CONSERVATION COMMISSION

re: #150 Arcadia Road – Minor Modification
Assessors Map 35, Lot 179

Sketch Plan rec'd
4/10/19
KLL

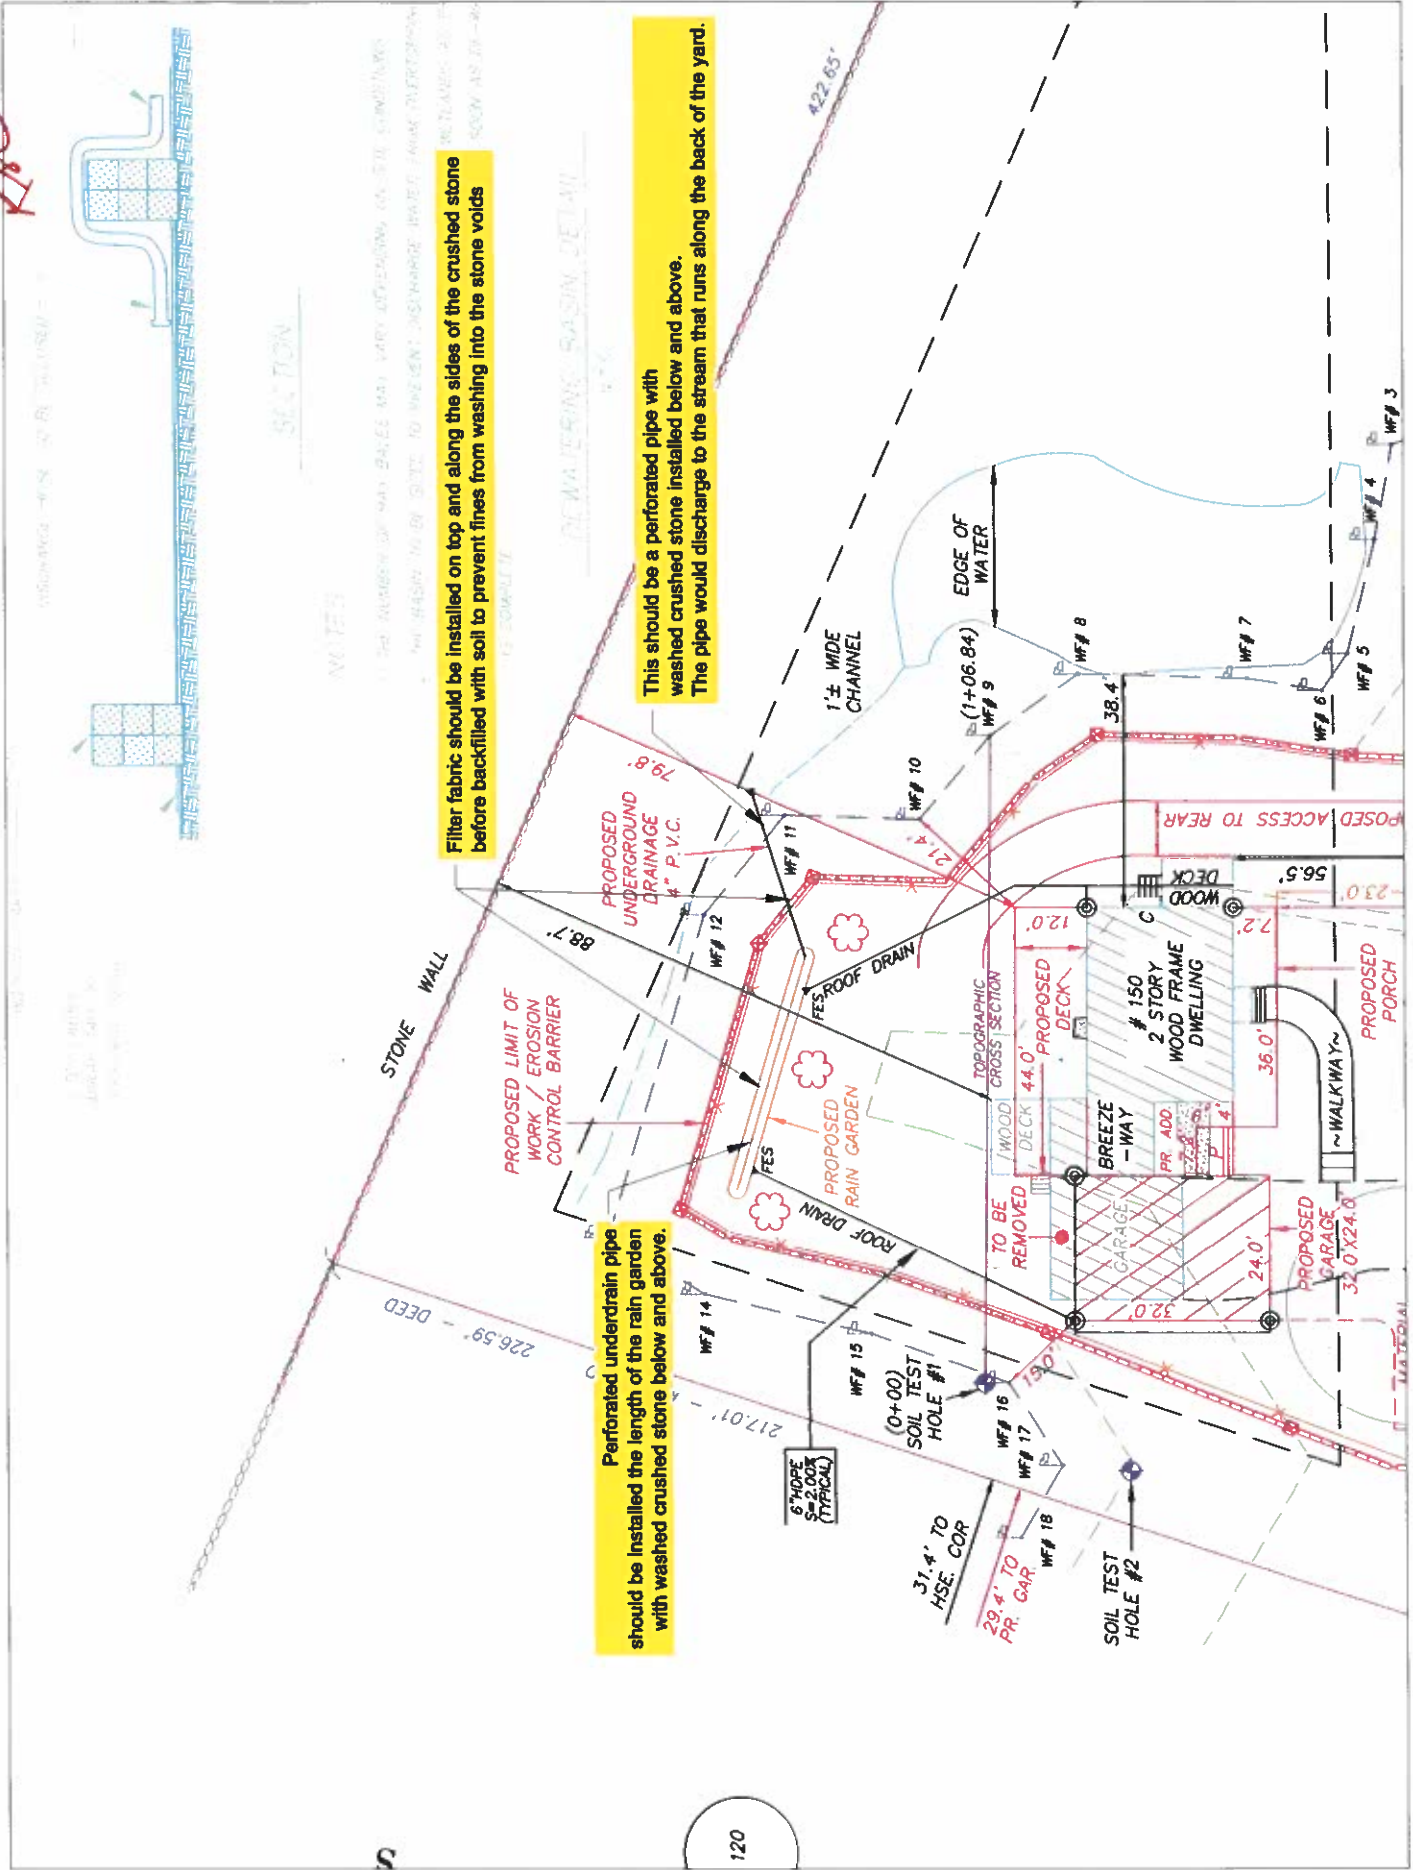
Please be advised that at their April 11, 2019 meeting, the Westwood Conservation Commission unanimously agreed that the proposed changes including installation of an underdrain in the raingarden to divert clean stormwater from roof drains and sump pump to the stream in heavy volume events as shown on the “sketch plan received 4/10/19” is not significant to the interest of the Wetland Protection Act or a significant change in the proposed approved plan and shall be considered a minor modification.

Filter fabric should be installed on top and along the sides of the crushed stone before backfilled with soil to prevent fines from washing into the stone voids

Perforated underdrain pipe should be installed the length of the rain garden with washed crushed stone below and above.

This should be a perforated pipe with washed crushed stone installed below and above. The pipe would discharge to the stream that runs along the back of the yard.
